ADDENDUM NO. 18

**Westfield Washington School Corporation
Centennial Road Reconstruction
Bid Package 05
17707 Centennial Road,
Westfield, IN. 46074**

ADDENDUM

PROJECT: Westfield Middle School – West

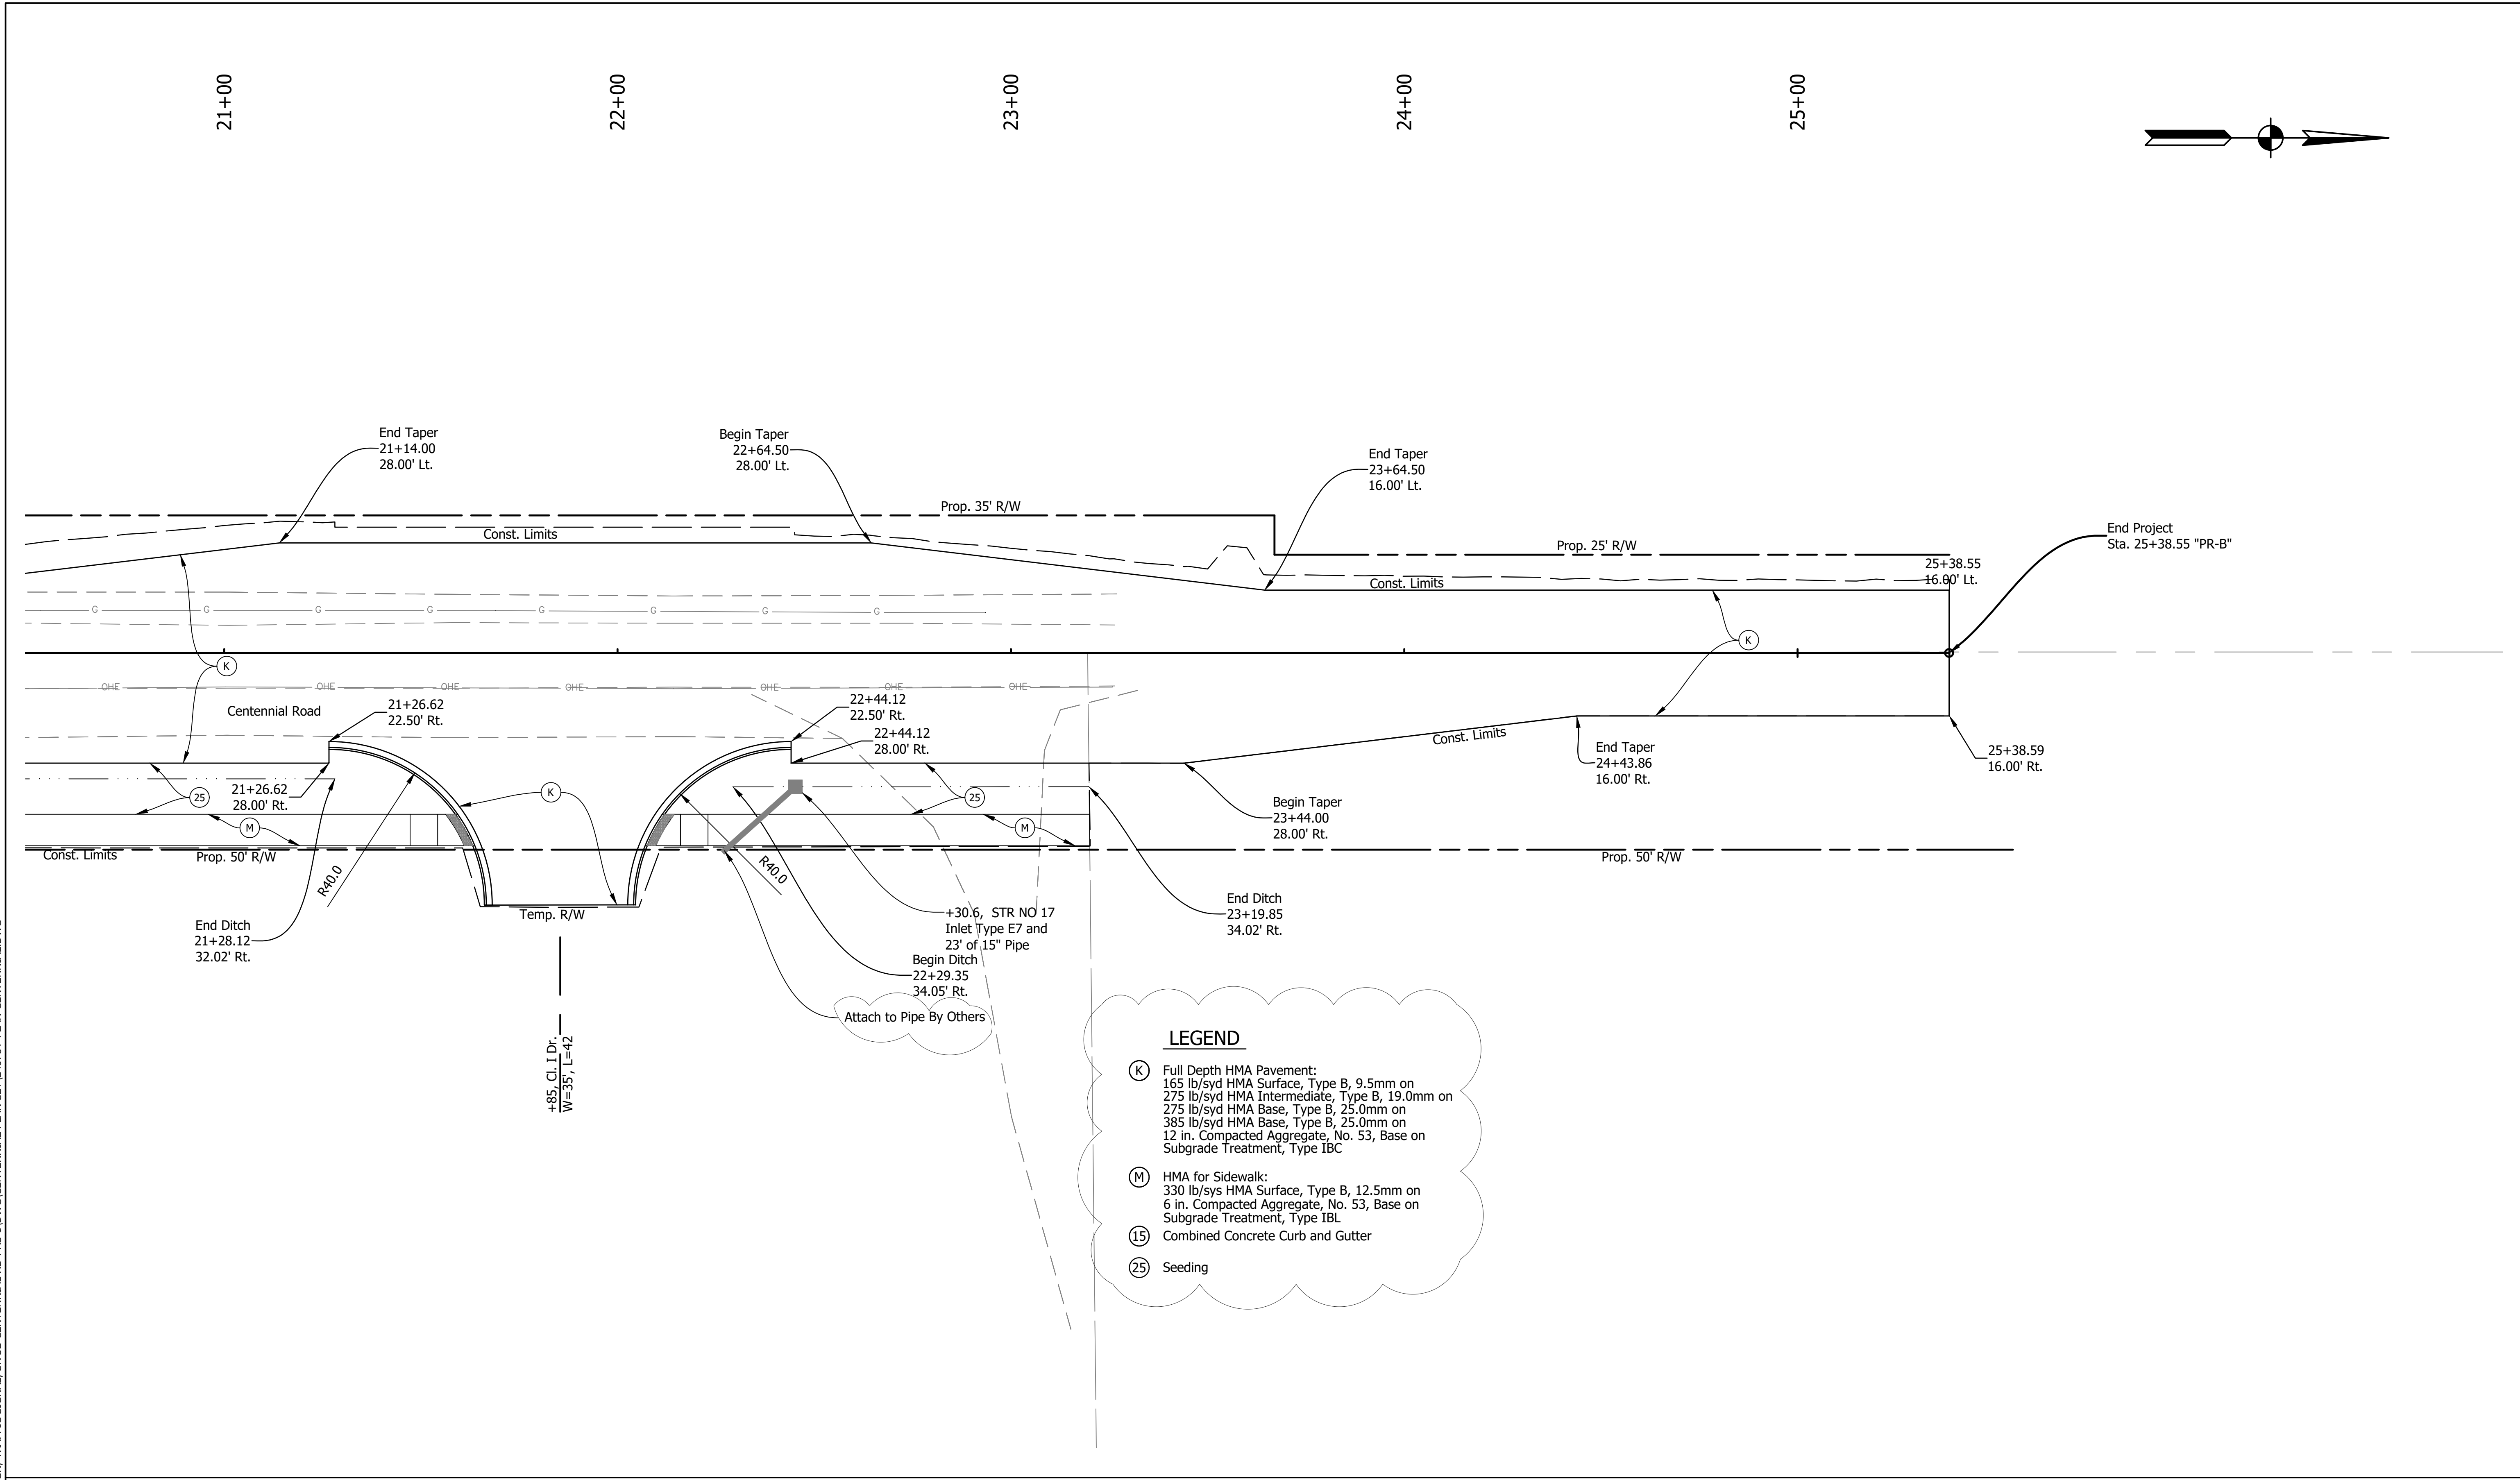
- 4.5 SHEET 14 - PLAN - LINE "PR-B" 22+00.00 to 28+00.00
- A. Added "Attach to Pipe By Others" note to Str. 17, updated legend
- 4.6 SHEET 16 - PLAN - LINE "PR-A" STA. 62+00.00 TO STA. 68+00.00
- A. Removed (C1) notes, updated legend
- 4.7 SHEET 17 - PLAN - LINE "PR-A" STA. 68+00.00 TO STA. 74+00.00
- A. Reissue sheet
- 4.8 SHEET 24
- A. Added Box Culvert Details
- 4.9 SHEET 25 - PAVEMENT QUANTITIES AND APPROACH TABLE
- A. Reissue sheet
- 4.10 SHEETS 27-48
- A. Recalculated Earthwork

WESTFIELD WASHINGTON SCHOOLS
MISCELLANEOUS DETAILS

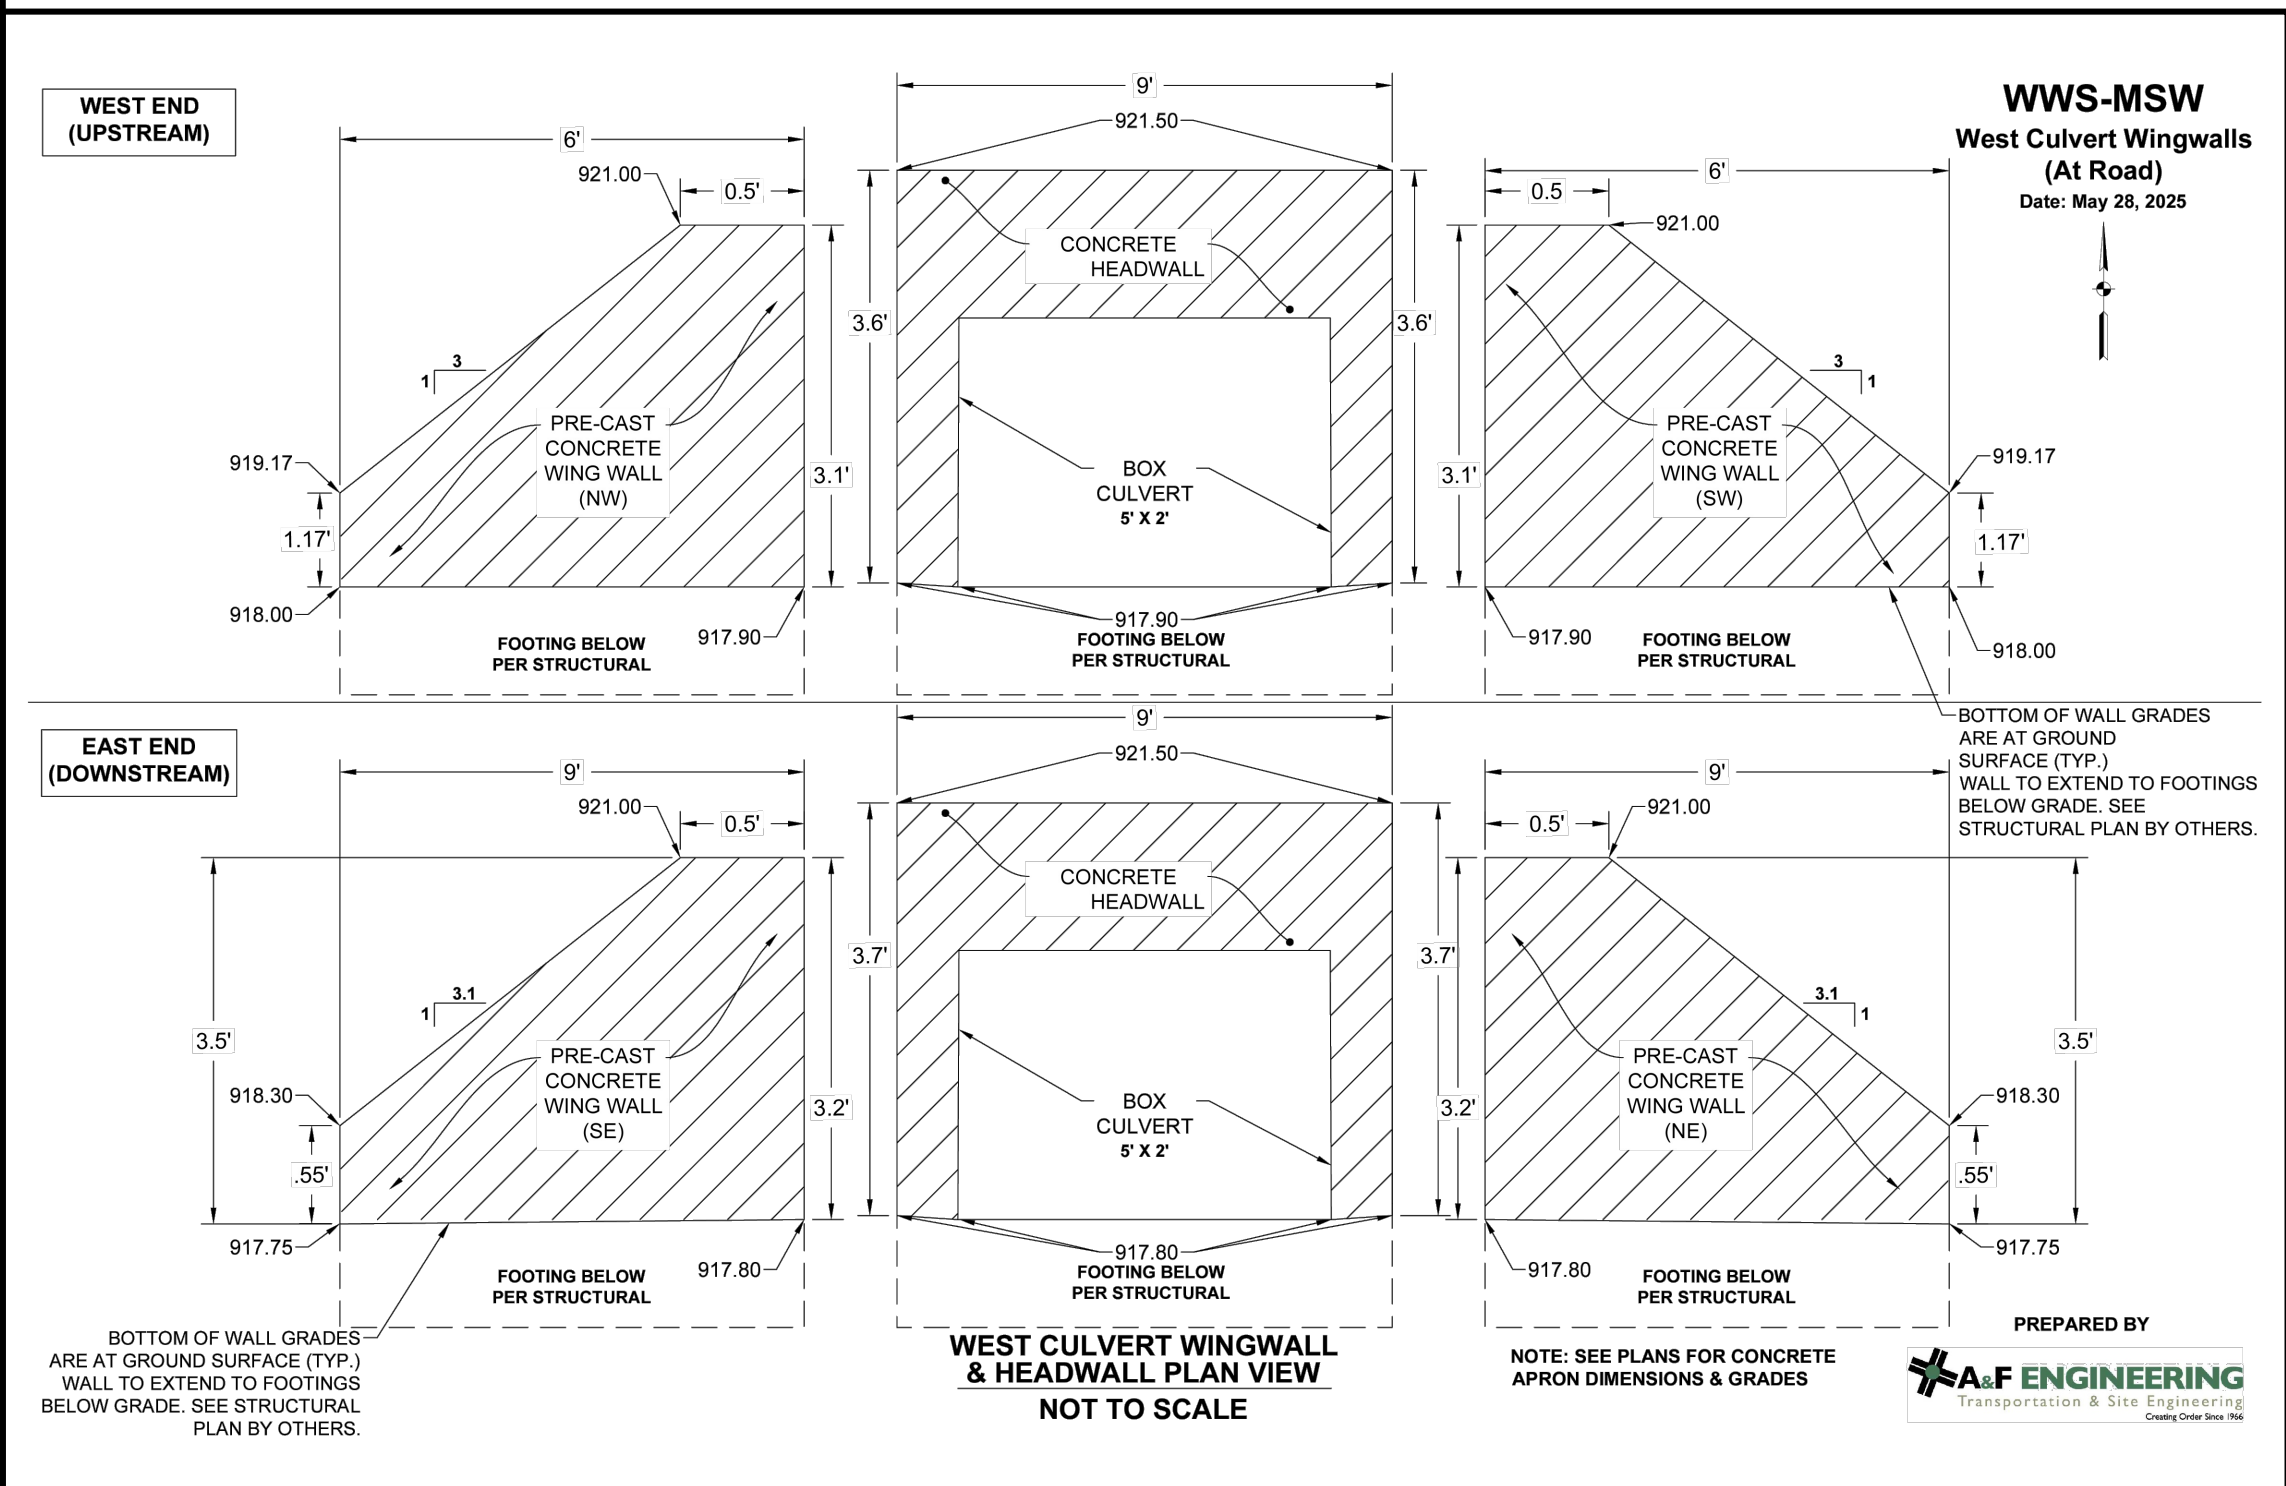
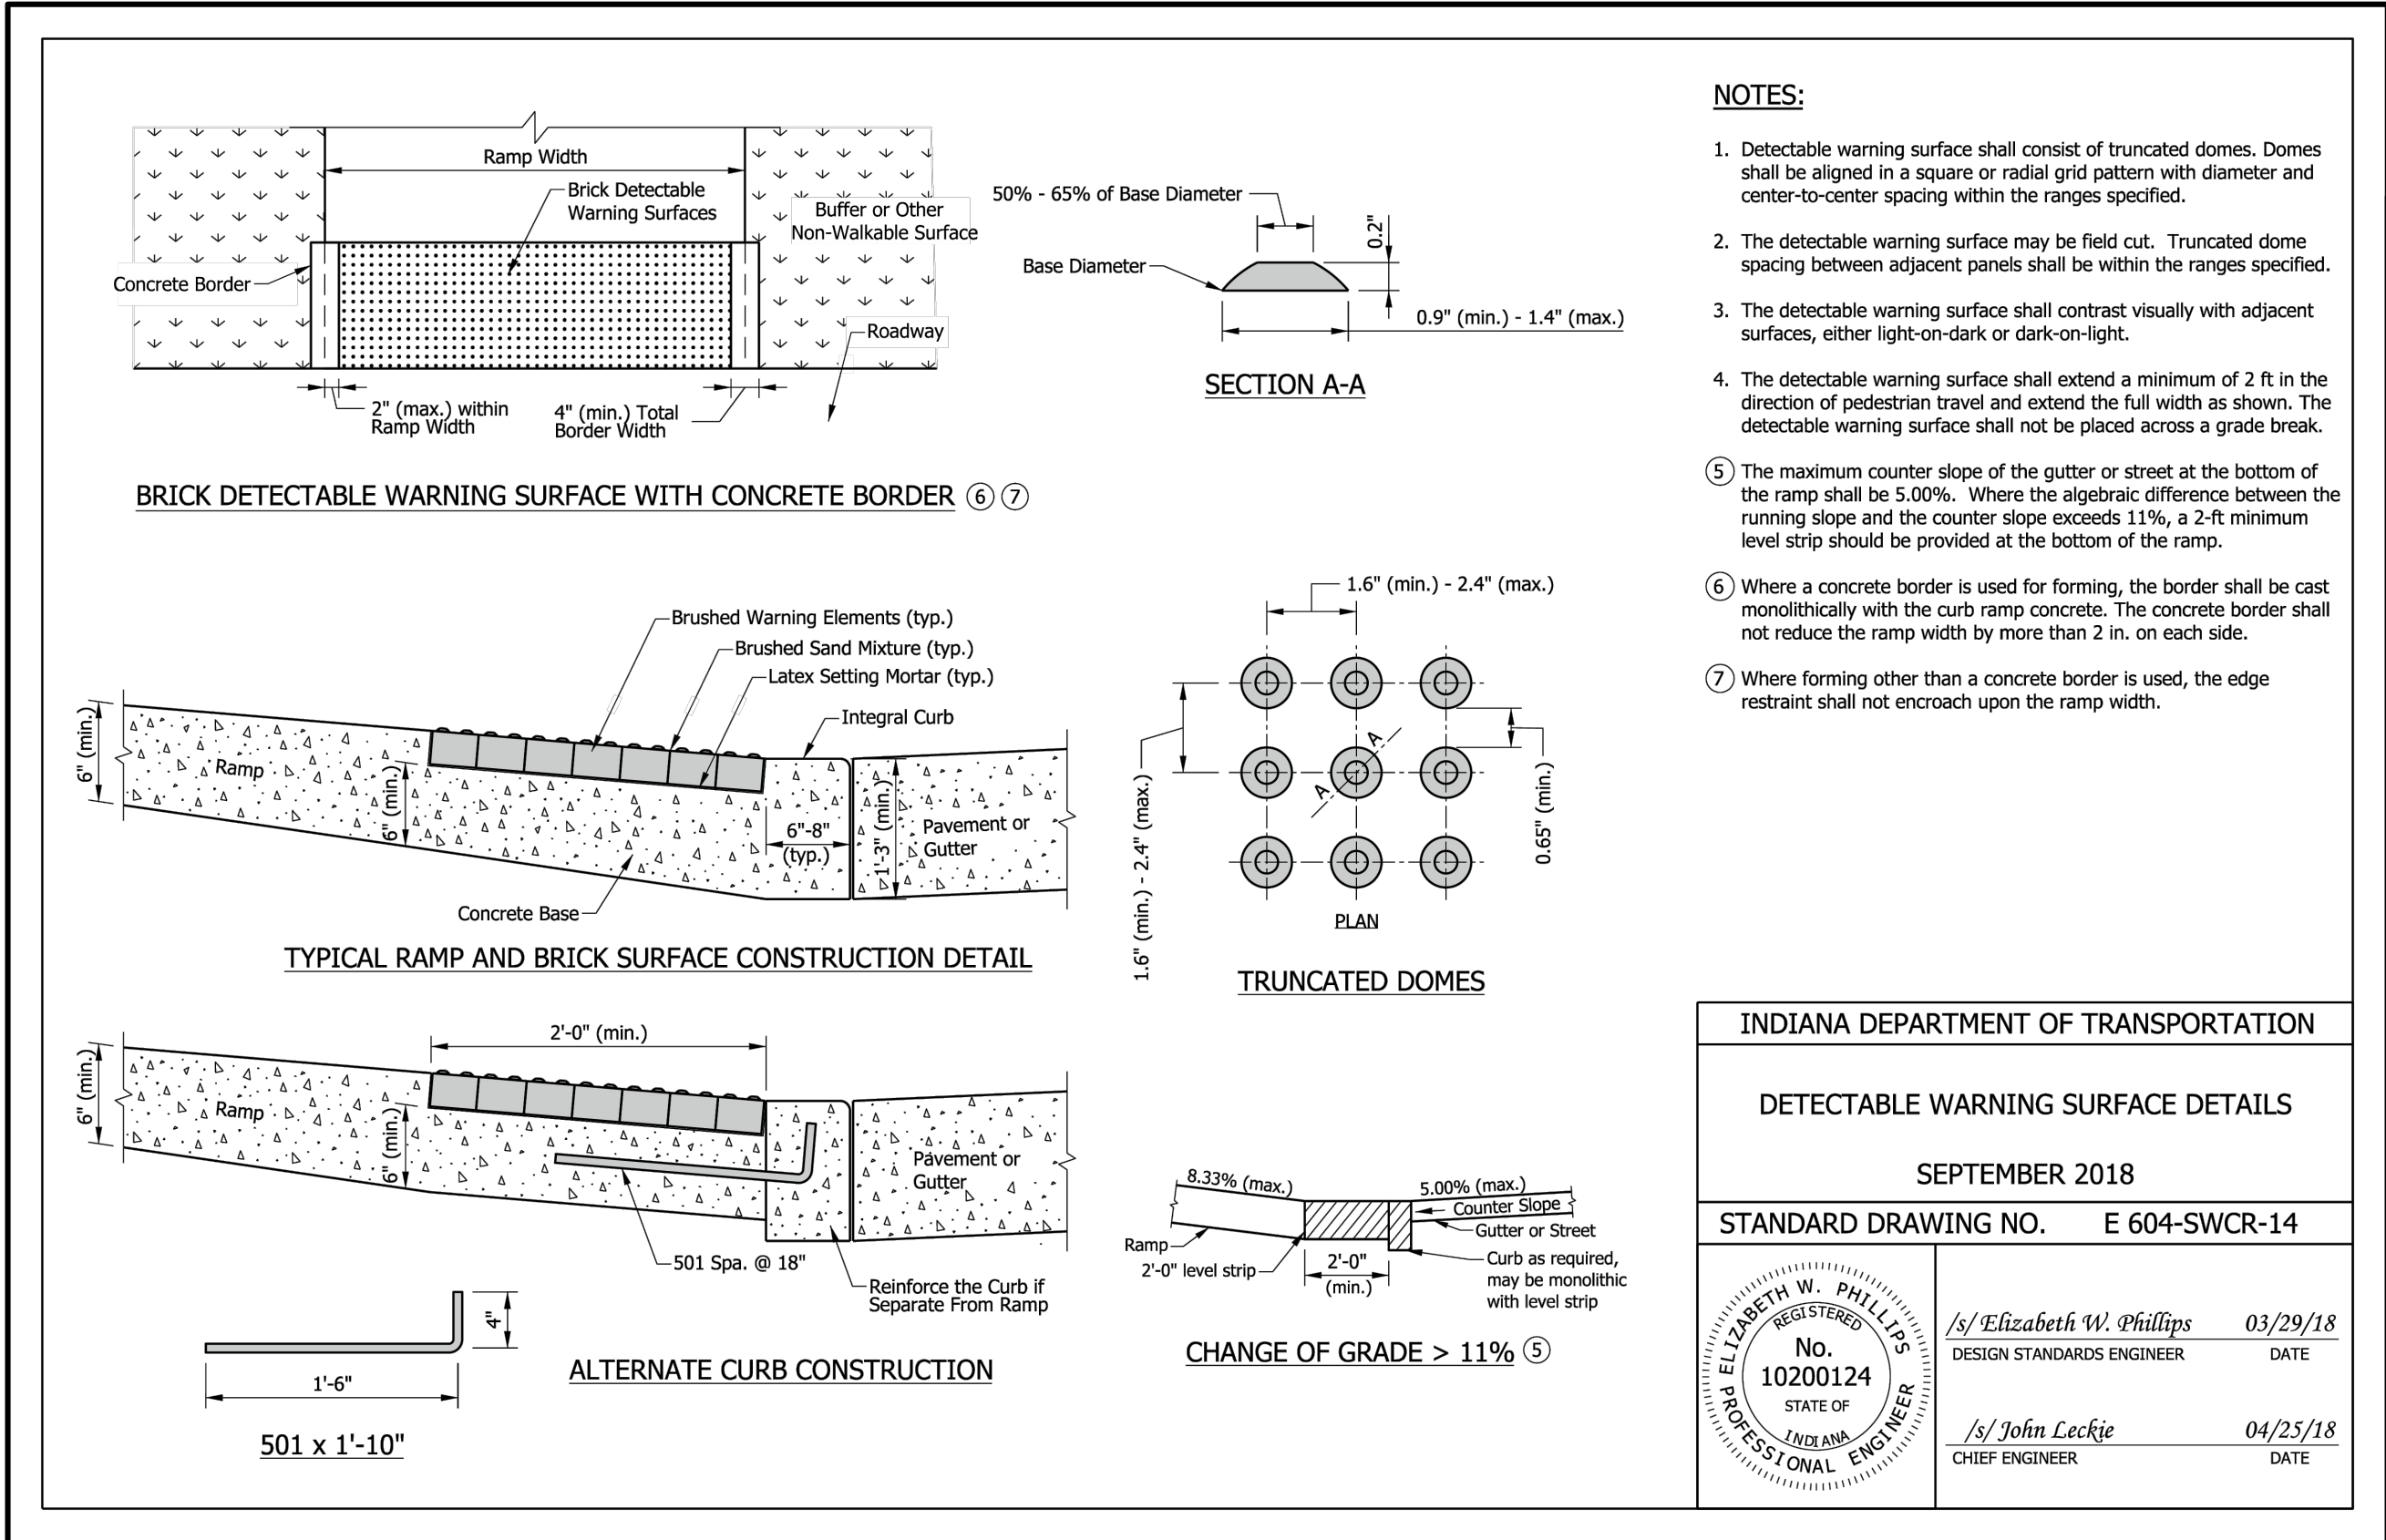
REVISIONS	
DATE	ITEM
Oct 2, 2025	Updated Str. 11A, Added detail notes to box culvert and casting
